- T12 Post-Production changes. Silk-screen, schematic and BOM changes needed to make the board match up to Service Manual. CAH 04 Aug 2016

Title			
CASSODAY SCRUB MODULE			
Size B	Document Number		Rev A
	O26012-002		
Date:	Thursday, August 04, 2016	Sheet 1 of 7

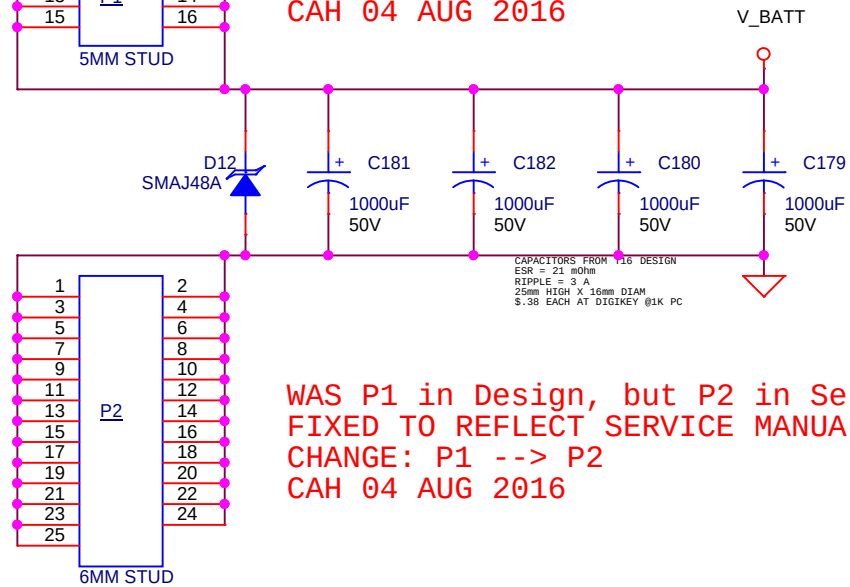
WAS P2 in Design, but P1 in Service Manual.
FIXED TO REFLECT SERVICE MANUAL.
CHANGE: P2 --> P1
CAH 04 AUG 2016

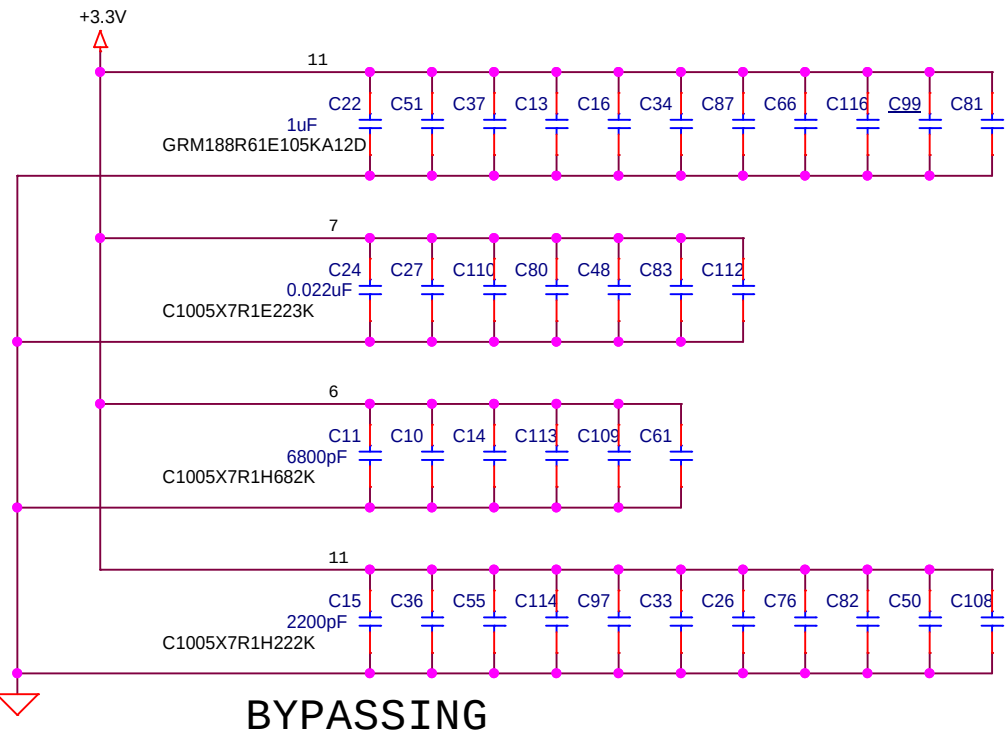
WAS P1 in Design, but P2 in Service Manual.
FIXED TO REFLECT SERVICE MANUAL.
CHANGE: P1 --> P2
CAH 04 AUG 2016
